# Access Compliance Report

## Public Rights-of-Way

Intersection ID: 12035	Main Street: WILKINSON_BV	Cross Street: FAIRHAVEN_ST	Location:	N
ADA ID: 54D8CD8BBDDDE	Ramp Type: Perp	Initial Pass/Fail: Fail	Overall Compliance: No	Severity Score: 25

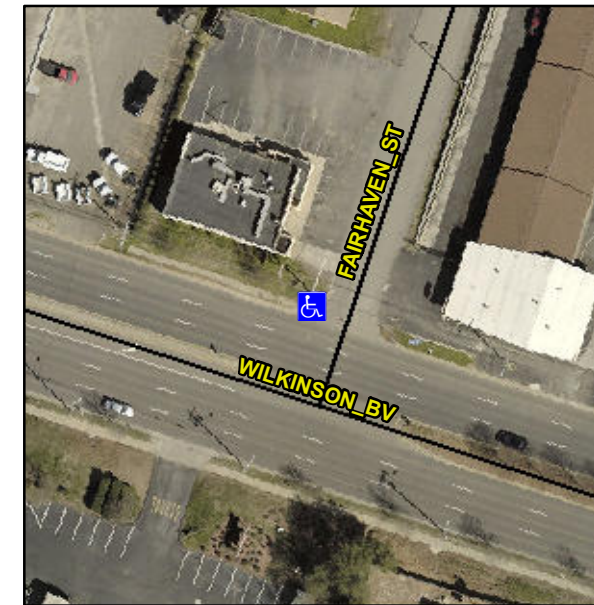
**R304.2.2, R304.5.3**

Compliance	Description	Data	Compliance	Description	Data
N/A	Ramp Length (in)	33.0	No	Ramp Slope (%)	8.9
Yes	Ramp Width (in)	48.0	No	Ramp XSlope (%)	5.2
N/A	Flare Type LT	N/A	N/A	Flare Type RT	N/A
N/A	Flare Slope LT (%)	N/A	N/A	Flare Slope RT (%)	N/A
N/A	Flare Traversable LT?	N/A	N/A	Flare Traversable RT?	N/A
N/A	Landing Length (in)	N/A	N/A	DWS Provided?	N/A
N/A	Landing Width (in)	N/A	N/A	DWS Contrast?	N/A
N/A	Landing Slope (%)	N/A	N/A	DWS Length (in)	N/A
N/A	Landing X Slope (%)	N/A	N/A	DWS Full Width?	N/A
N/A	Landing Curb? (Y/N)	N/A	N/A	DWS Offset (in)	N/A
N/A	Shared Landing?	N/A			
N/A	Gutter Ponding?	N/A	N/A	Gutter Slope (%)	N/A
N/A	Gutter Lip Ht (in)	1.0	N/A	Gutter X Slope (%)	N/A
N/A	Painted X Walk1?	No	N/A	Painted X Walk2?	N/A
	X Walk 1 Direction	To SE		X Walk 2 Direction	N/A
N/A	X Walk 1 Width (in)	N/A	N/A	X Walk 2 Width (in)	N/A
	X Walk 1 Slope (%)	2.3		X Walk 2 Slope (%)	N/A
	X Walk 1 X Slope (%)	2.6		X Walk 2 X Slope (%)	N/A

**Remove & Replace Entire Ramp.**
